**Subject: Docket Nos. 50-361 and 50-362
Additional Information Regarding Generic Letter 96-06 "Assurance
of Equipment Operability and Containment Integrity During
Design-Basis Accident Conditions,"
San Onofre Nuclear Generating Station, Units 2 and 3
(TAC Nos. M96862 and M96863)**

**Response to the Request for Additional Information
Regarding the September 29, 2003
Supplemental Response to Generic Letter 96-06
"Assurance of Equipment Operability and Containment Integrity
During Design-Basis Accident Conditions"**

MSLB @ 102% POWER W/MSIV FAILURE CONTAINMENT PRESSURE

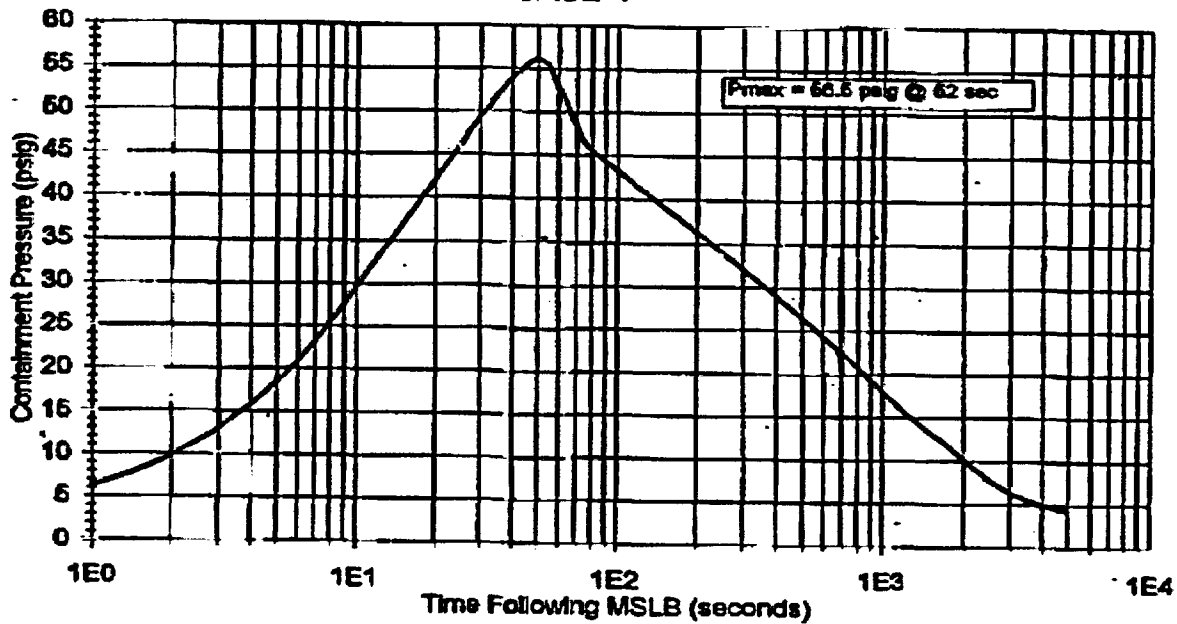
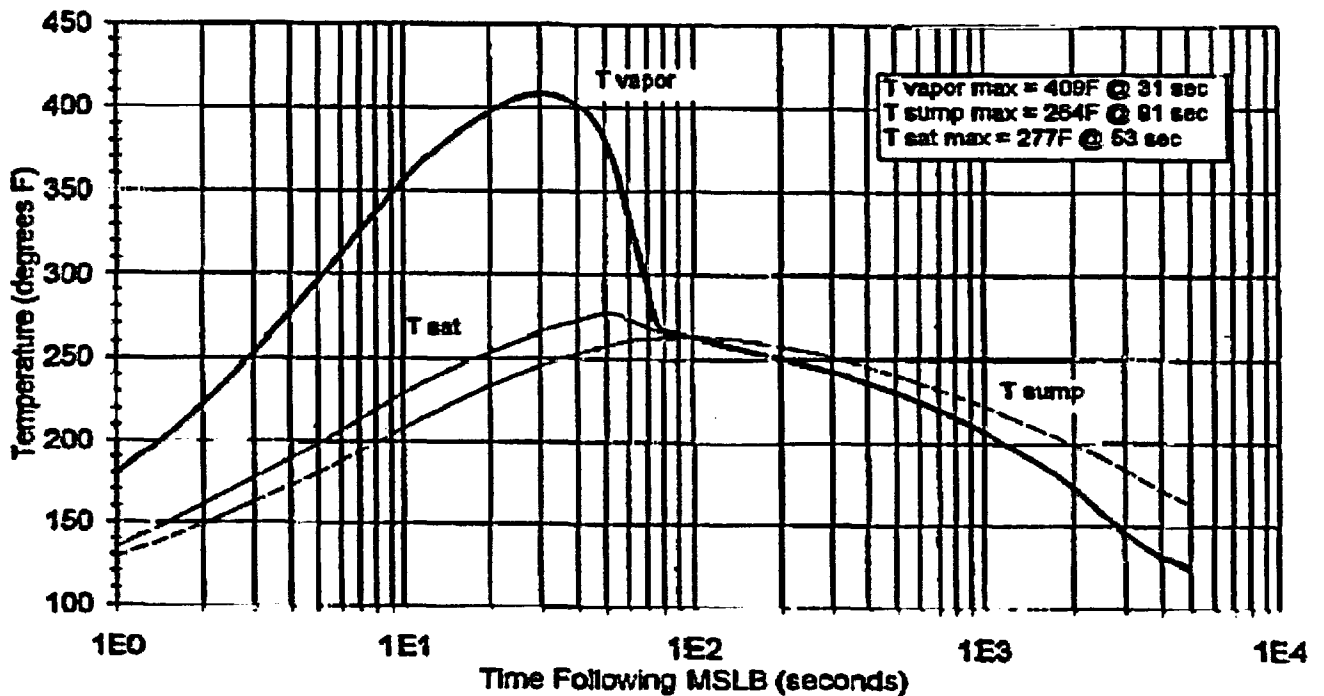
Provide graphs showing the containment atmospheric temperature and pressure as a function of time for both the LOCA and MSLB case.

The condensation heat transfer coefficients (for saturated steam) are significantly greater than the sensible heat convective heat transfer coefficients for superheated vapor. As shown in the attached figures (see page 12), the saturation temperatures for the MSLB are much lower than the containment temperatures. Thus, the steam in MSLB is significantly superheated. Hence, for steam to begin condensing over the ECU tubes it has to first pass over successive cooler tubes to cool down to the saturation temperature and lose the superheat by convection.

The MSLB and LOCA pressure and temperature curves are provided on pages 12 and 13, respectively, of this response.
